From: Tavarez, Ike [Ike.Tavarez@tetrattech.com]
Sent: Wednesday, January 19, 2011 3:13 PM
To: Bratcher, Mike, EMNRD
Subject: RE: COG - Mesilla State #3 TB Work Plan Approval Request

**Re: Work Plan for the COG Operating LLC., Mesilla State #3 , Unit H,
Section 16, Township 17 South, Range 30 East, Eddy County,
New Mexico.**

Figure 3
 Mesilla State #3
 Site Assessment Map
 Eddy County, New Mexico

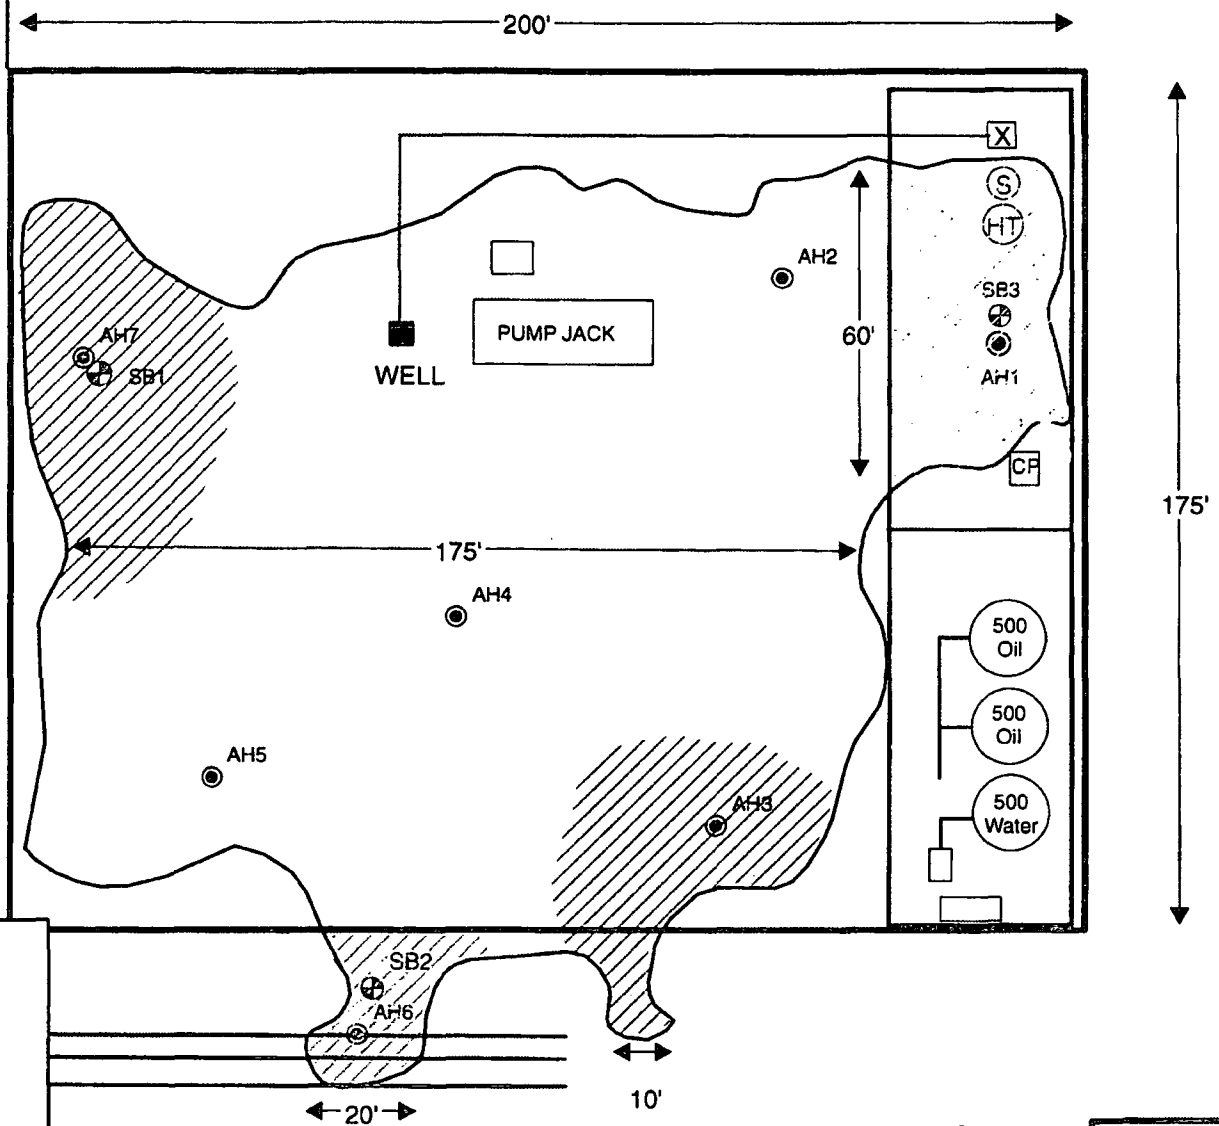
Will you review the labeling on the diagrams? I think SB-3/AH-1 and SB-2/AH-6 may be mislabeled.

You are correct. I will make the changes and re-submit the work plan. Thanks
